SUBMISSION OF OBJECTION

Re: Submission to exhibition of SSD-85974227 at 9-17 Balfour Street, Lindfield

I am writing as the owner of 14 Highfield Road Lindfield in relation to SSD-85974227 at 9-17 Balfour Street Lindfield ("the development site").

Above diagram: Summer Solstice at 6:00am on 21 December, showing shadows over properties in Highfield Road Lindfield.

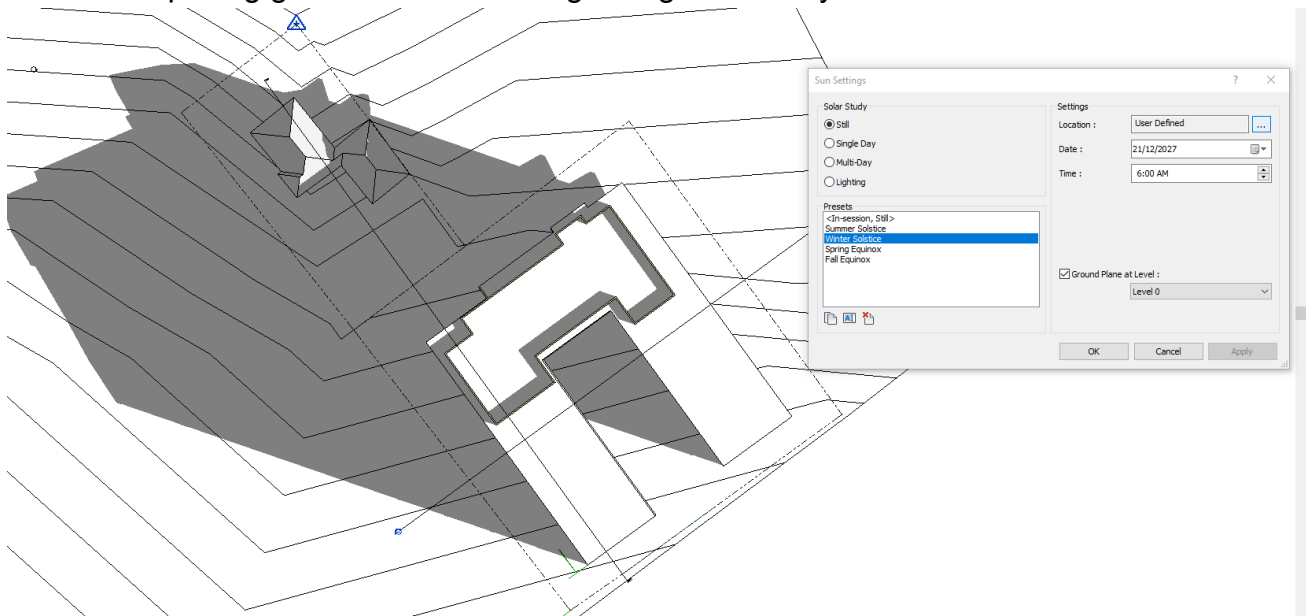
- Inadequate building setbacks do not meet the KLEP or ADG (Apartment Design Guide). Should be 10m at front but plans only allow 6m. When adjacent to a Heritage Item or a Heritage Conservation Area (HCA), increased setbacks are required, and these have not been met. The side setback near the school playground appears to be only 3m for most of the length.
- P.37 - Inadequate solar access to units: 17 get no solar access in winter; 34 units have less than 2 hours per day. Solar access has only looked at winter solstice on a building height of 28.6m. This development will stand at 33.2m, thus the shadow diagrams are incorrect and should not be relied upon. No consideration of the shadow impacts in summer depriving gardens from morning sunlight that they are used to.

- Exceeds height restraint of 28.6m by 4.6m, standing at a finished height of 33.2m. Nothing has been documented in the report of how our summer morning sun is affected. Our gardens will be in the dark until after midday and plants and trees relying on the morning sun for their health and benefit will be missing, along with our mental health benefits.
